Approved Septic System Plan
Howard County Health Department

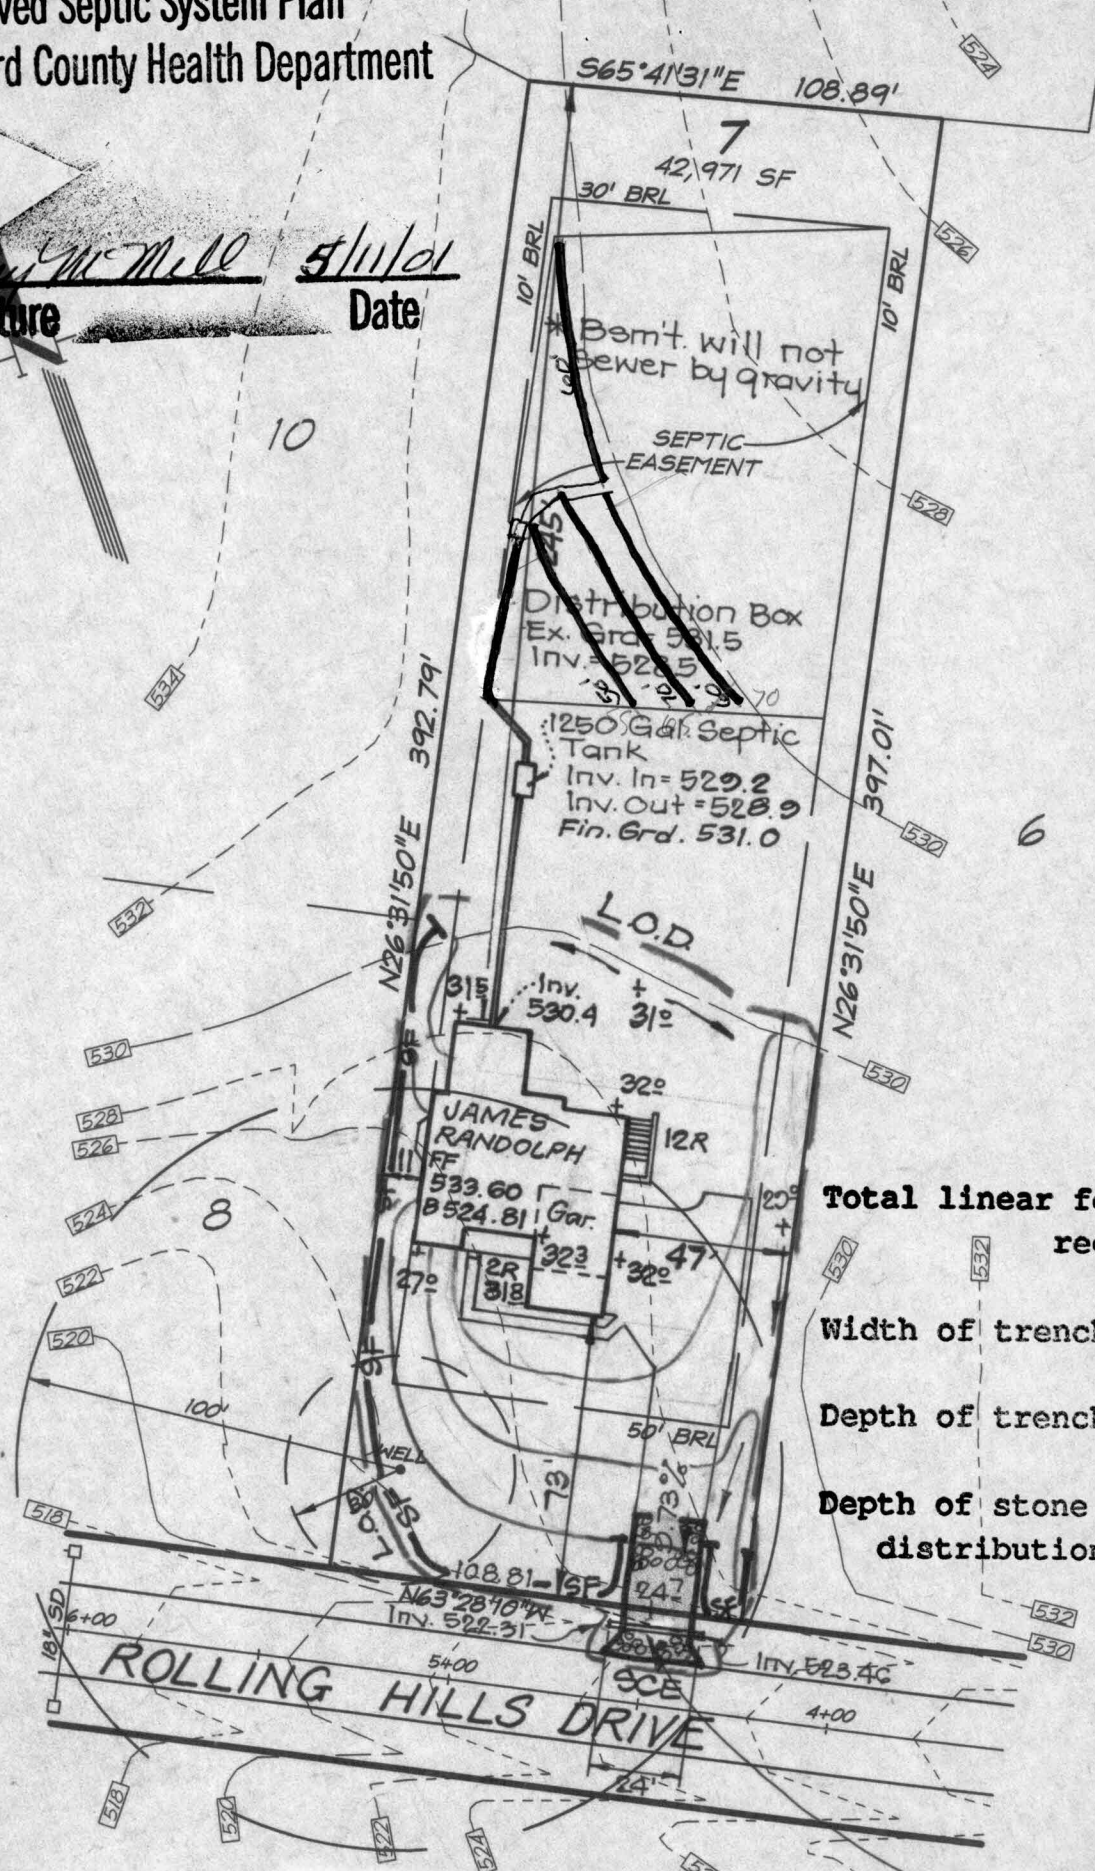
Total linear feet of trench required 240 feet
 Width of trench(es) 3.0 feet
 Depth of trench(es) 6.0 feet
 Depth of stone required below distribution pipe 2.0 feet

Provide 9' 14"x9" CMU way curb H.C. Co. De
